STATE OF NORTH CAROLINA
DEPARTMENT OF TRANSPORTATION

Subject: DCM Consistency for the proposed US 70 Havelock Bypass in Craven County. TIP No. R-1015. WBS 34360.1.2.

The North Carolina Department of Transportation (NCDOT) submitted additional information on Havelock Bypass to you on March 13, 2020 for review in regards to the Division of Coastal Management's CAMA Consistency Determination for the project. This package included supplemental information and revised permit drawings. Based on further coordination with the NC Division of Water Resources, further revisions need to be made to this request. This letter is a revised version of the March 13, 2020 request, showing additional and modified information highlighted in red.

PERMIT DRAWING SHEET 35 OF 167

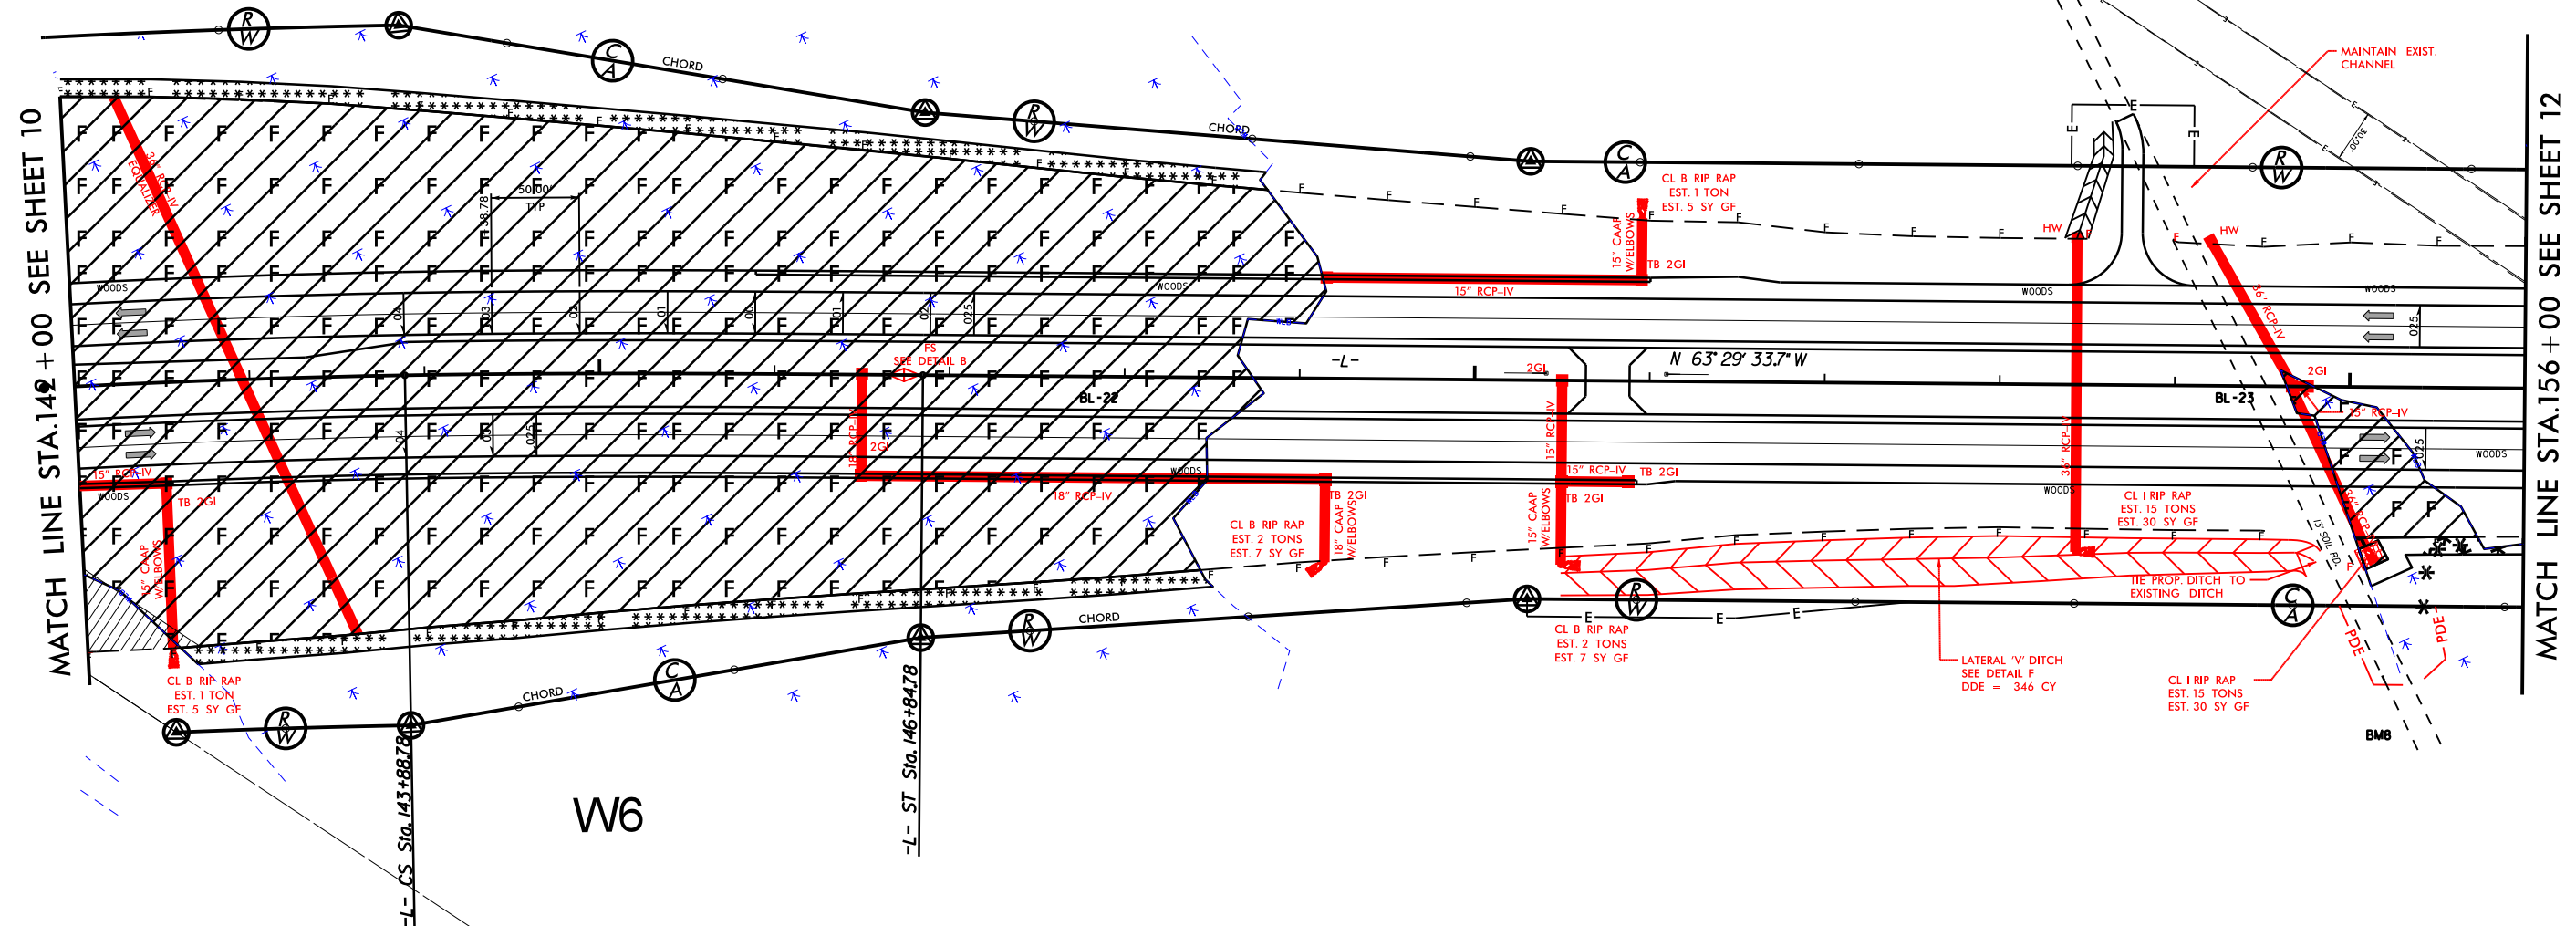
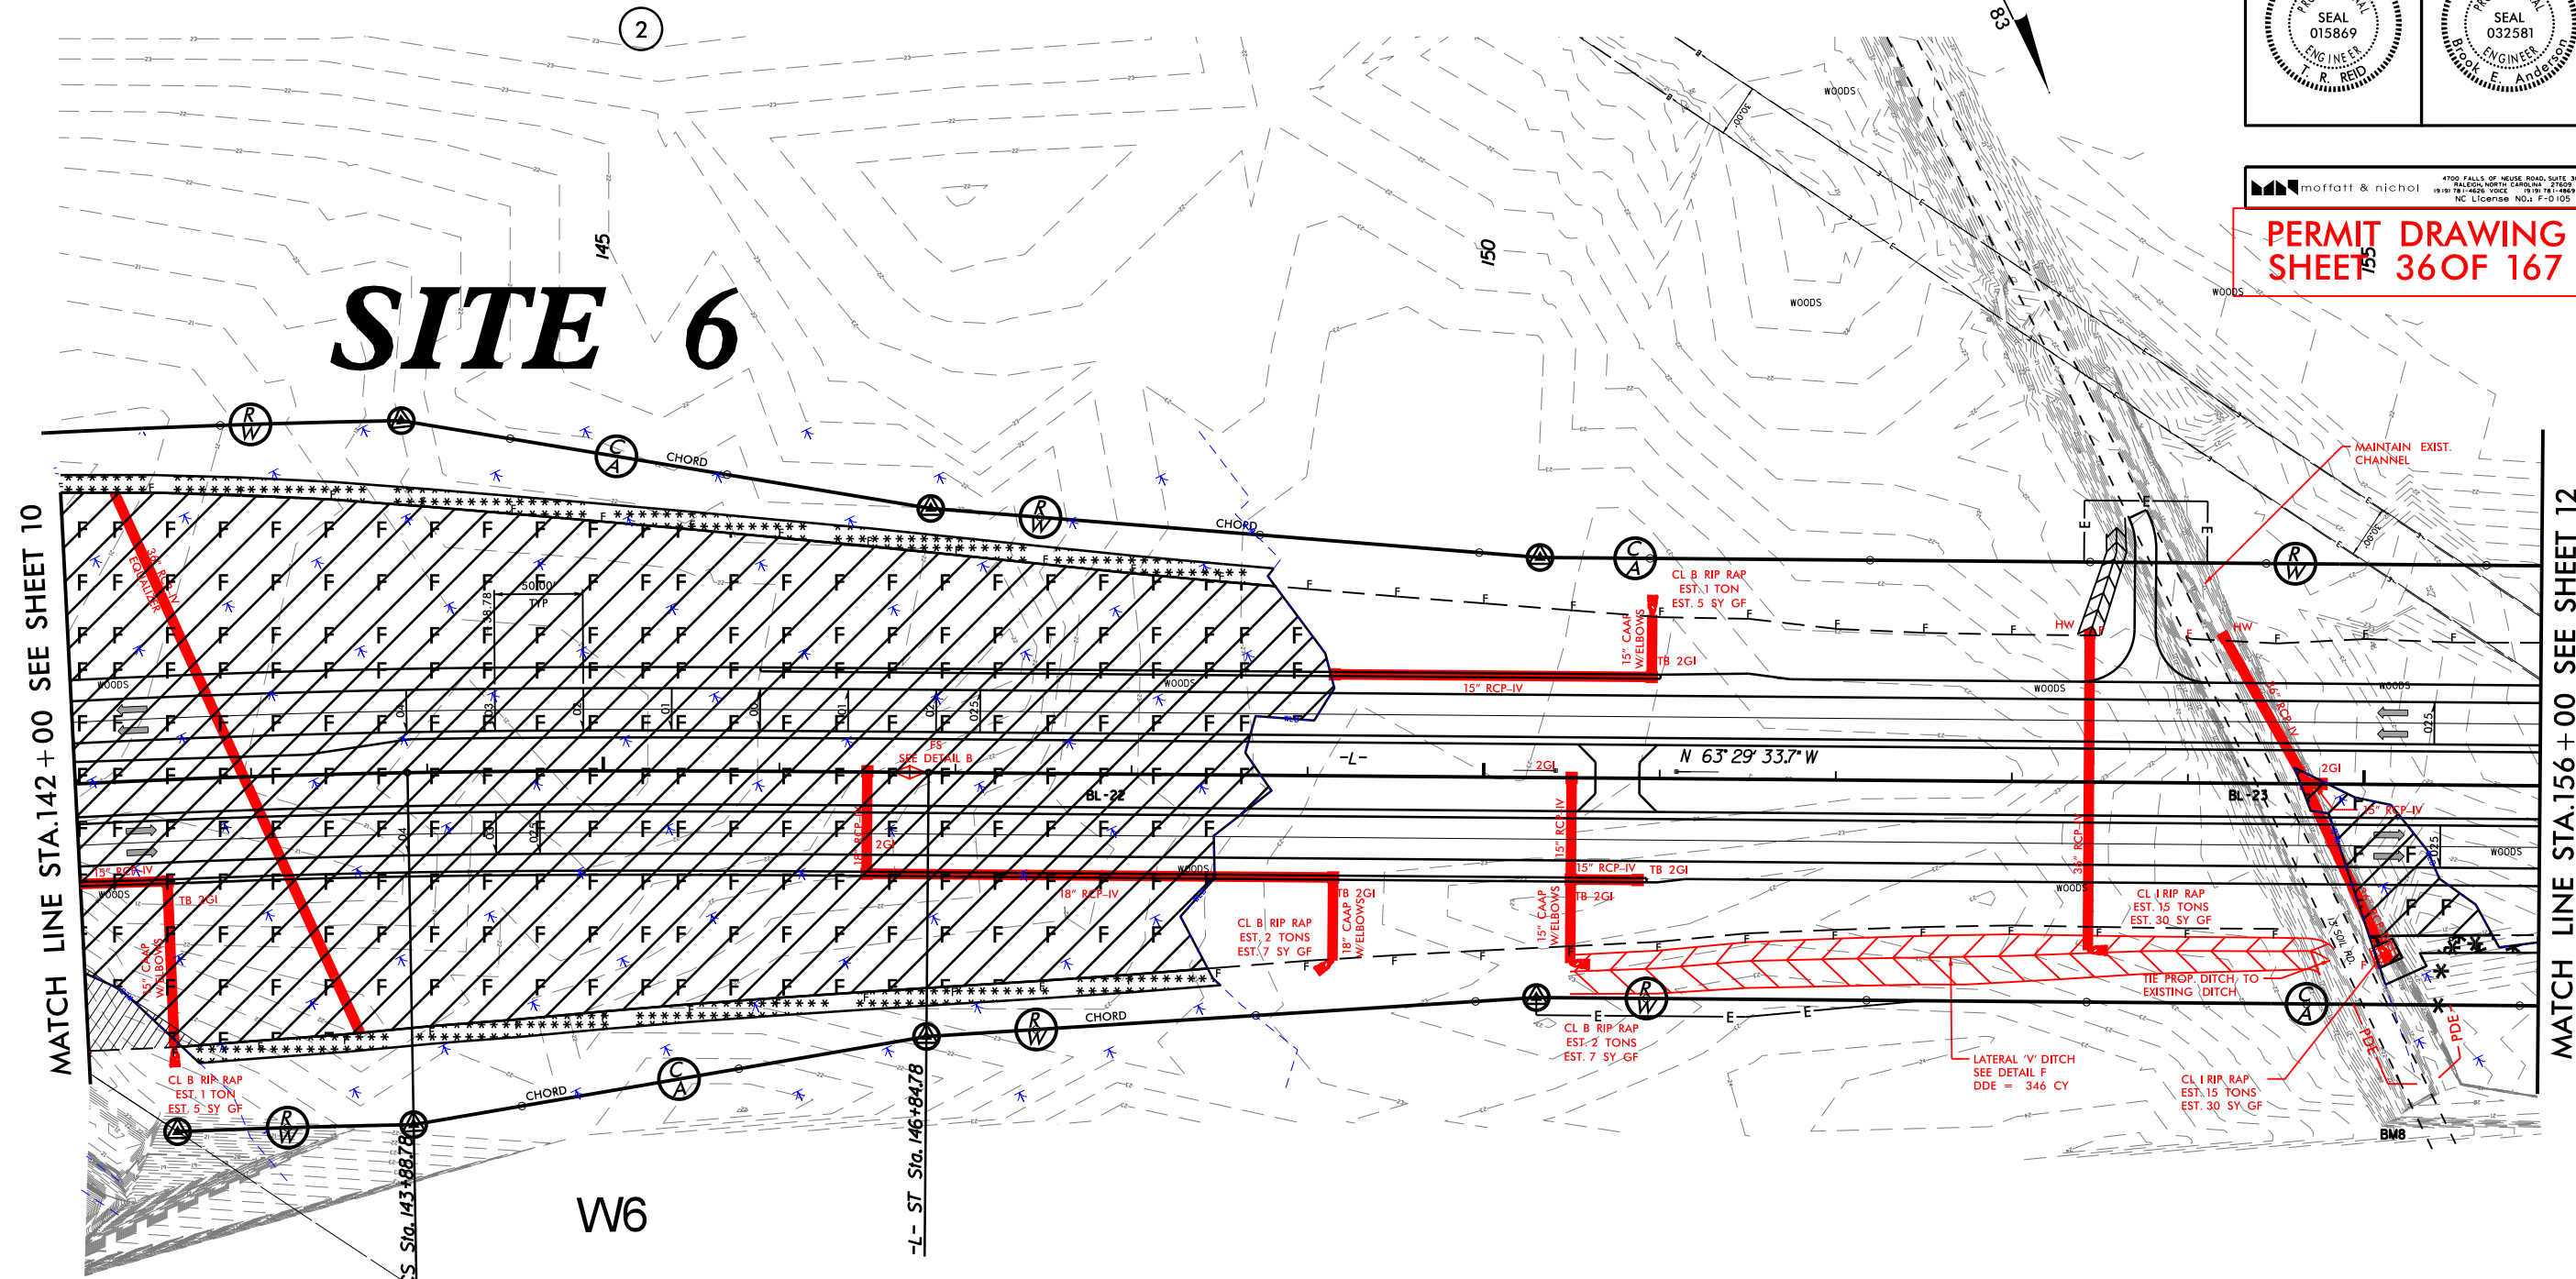
- Site 7: omitted in 3/12/20 modification request, (permit sheets 35 & 36). Access driveway was removed. Fill in wetlands reduced by 0.04 acre. Mechanized Clearing reduced by 0.01ac.
